Report on Groundwater Flow and Contamination at
Chemical Waste Management, LLC,
Model City, New York, and
Proposed RMU-2 Permitting and
Siting Issues

Prepared for Niagara County, the Town of Lewiston and
the Villages of Lewiston and Youngstown, New York

November, 2014

Andrew Michalski, Ph.D., CGWP, PG, LSRP

Figure 1: CWM Hydrostratigraphic Model

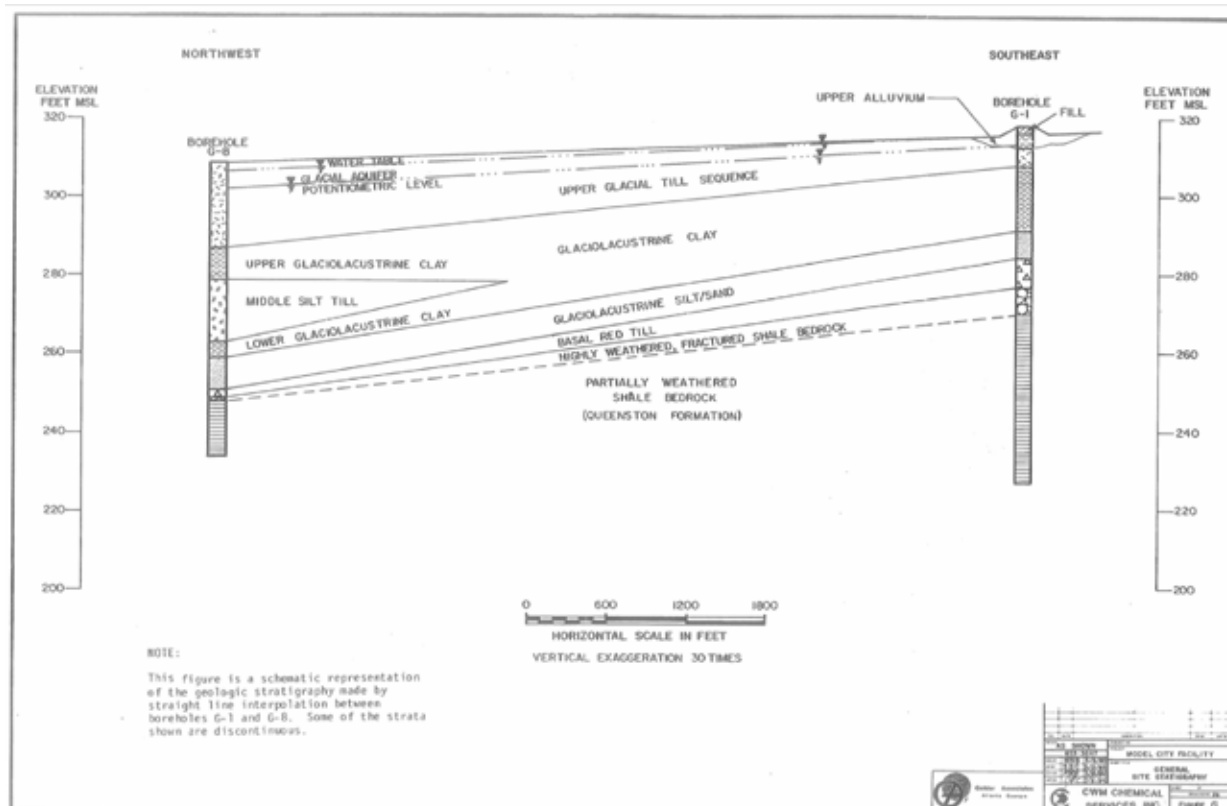
The conceptual hydrostratigraphic model of the CWM site used by the Applicant posits that a “lower aquifer” and an “upper aquifer” underlie the site, separated by an effective aquitard. See Figure 1, below (from Golder (1993), vol. 1, Fig. 6; reproduced unchanged at Golder (2014b), Fig. 3; and below, Figure 1. These two hydrogeological units are separated by a Glaciolacustrine (lake bottom) Clay unit, the posited low permeability aquitard. Over the northwestern portion of the facility, including the RMU-2 footprint, this unit is separated into an upper and lower

The Applicant's hydrostratigraphic model, originally proposed by Golder (1985), was slightly modified by Golder (1993), and has been incorporated unchanged into the Application. *See* DEIS, 55-59; CWM (2013b) (Groundwater Sampling and Analysis Plan); Golder (2014) (Hydrogeologic Update). However, results of previous hydrogeologic investigations of the site, and those undertaken at the adjacent Modern Landfill and NFSS facilities are not consistent with the model. The latter investigation is recent and the most comprehensive, encompassing all three properties. *See* USACE (2007). In addition, much of the raw data generated by the Applicant's investigations are not consistent with its model. Specifically, the Applicant has disregarded the very large permeability variations within the lower aquifer unit, and has misinterpreted potentiometric surface maps of this unit, groundwater flow direction, and both horizontal and vertical contaminant migration rates within the geologic units.

FIGURE 5: Hydraulic conductivity distribution in GSS unit (RMU-2 landfill vicinity)

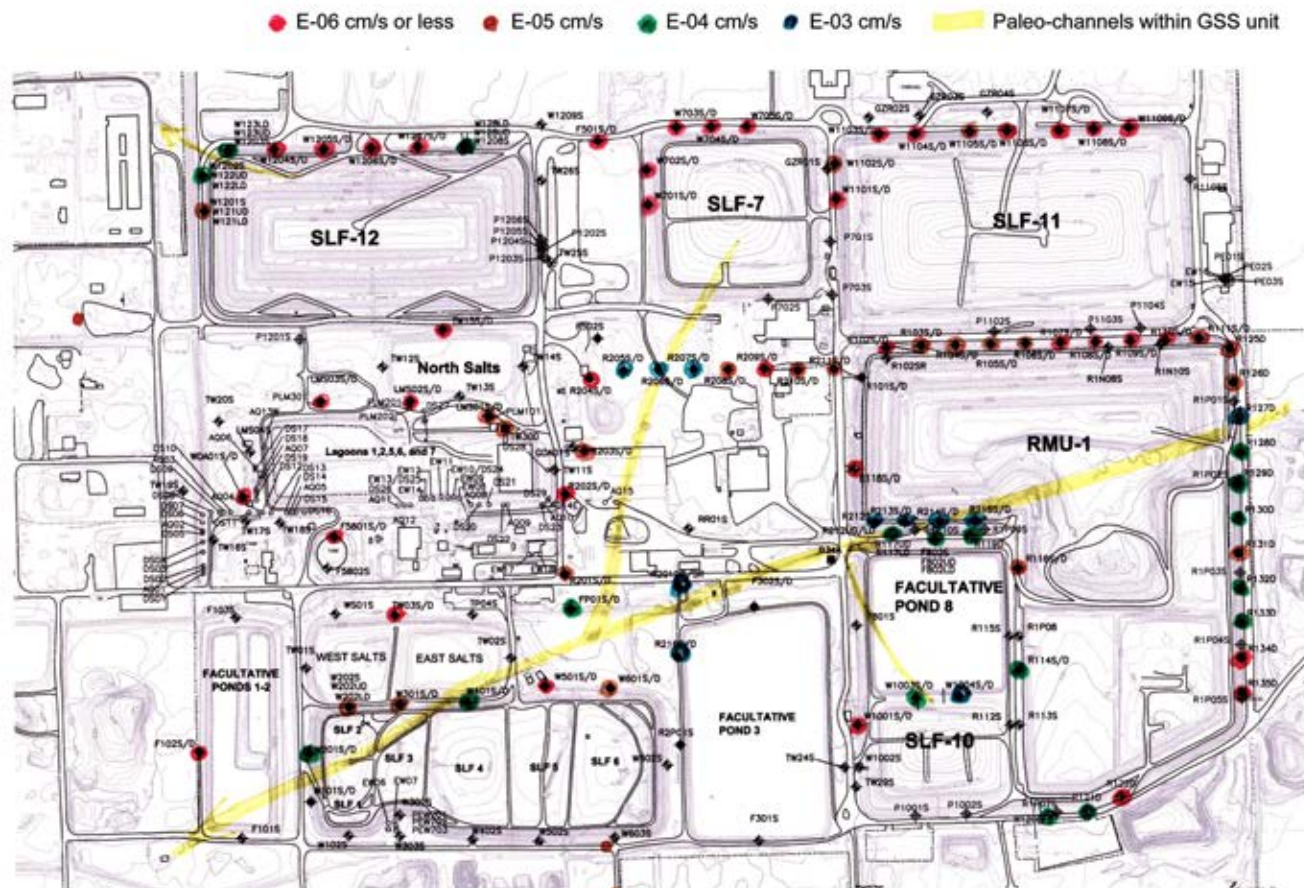
Using the hydraulic conductivity (k) data from all wells completed in the GSS unit from Table 5 in Golder (2014), we prepared a map showing distribution of this hydraulic parameter within the CWM site (Figure 5). Whereas the GSS unit is represented by low-permeability deposits over most of the site, there is a well-defined pattern of high permeability areas ($k > 10^{-4}$ or E-04 cm/s) along the buried valley filled with sand and gravel deposits. In addition to the main trunk of the buried valley (running from ENE to WSW), a tributary valley filled with high permeability deposits is interpreted to run from SLF-7 toward SLF-5 (Figure 5). This interpretation is corroborated by the configuration of the top of basal till surface (Figure 6). The depressions in this surface represent paleo-channels that coincide with the channels shown on Figure 5 and interpreted based on the hydraulic conductivity distribution within the GSS unit.

Given the pattern of hydraulic conductivity distribution depicted on Figure 5 and the presence of buried alluvial channels interpreted in Figure 6, it is apparent that the Applicant’s concept of GSS unit/aquifer is misleading and improper. The only true aquifer in the vicinity of the proposed RMU-2 landfill is represented by alluvial/glaciofluvial sand and gravel bodies deposited in the buried channels. These sand and gravel channels should be considered to be a separate unit. Because these elongated bodies provide preferential flow and contaminant
